<b>MEETING:</b>	<b>PLANNING COMMITTEE</b>
<b>DATE:</b>	<b>26 April 2017</b>
<b>TITLE OF REPORT:</b>	<b>163364 - SITE FOR 3 DETACHED DWELLINGS WITH GARAGES AND ACCESS AT LAND SOUTH OF LADYWELL LANE, KINGSTHORNE, HEREFORD</b>  <b>For: Mrs Croke per Mr Russell Pryce, Unit 5, Westwood Industrial Estate, Ewyas Harold, Hereford, Herefordshire HR2 0EL</b>
<b>WEBSITE LINK:</b>	<a href="https://www.herefordshire.gov.uk/info/200142/planning_services/planning_application_search/details?id=163364&amp;search=163364">https://www.herefordshire.gov.uk/info/200142/planning_services/planning_application_search/details?id=163364&amp;search=163364</a>
<b>Reason Application submitted to Committee – Redirection</b>

**Date Received: 20 October 2016**

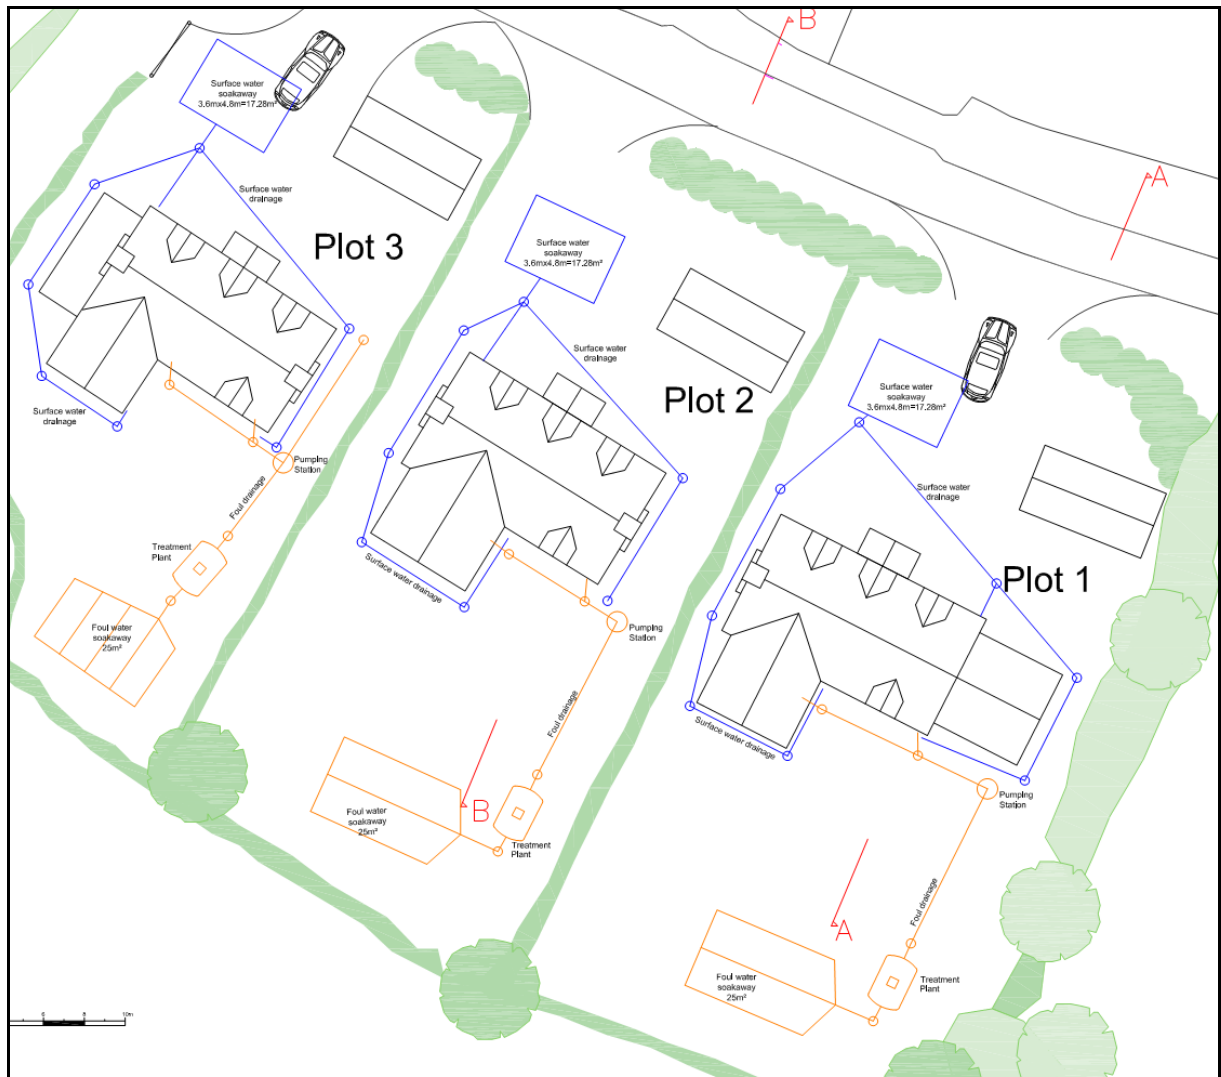
The Applicant is proposing to use package treatment plants to manage foul sewage. The layout plan shows the pumping station located near the corner of the house. This may be subjected to blockages from materials within the waste water. Following convention it is normal to align the drains to discharge into the package treatment plant then pump the treated effluent uphill. Please submit trade literature that supports the proposal to install the pumping station at the corner of the building.

4.4.9 We note that the package treatment plant for Plot 3 is located within 7m of the habitable building. This does not comply with BS6297. The Applicant must relocate the package treatment plant to be a minimum of 7m away from any habitable buildings.

4.4.10 The Applicant should consult with the EA regarding the use of a package treatment plant or other on-site method of wastewater treatment and disposal.

- The Applicant must clarify the proposals for the construction of the driveway;
- The foul water drainage strategy presented does not allow for the potential of blockage of pumping station. The Applicant must re-submit the foul water drainage strategy.
- The Applicant must relocate the package treatment plant for Plot 3 to be a minimum of 7m from the habitable building.
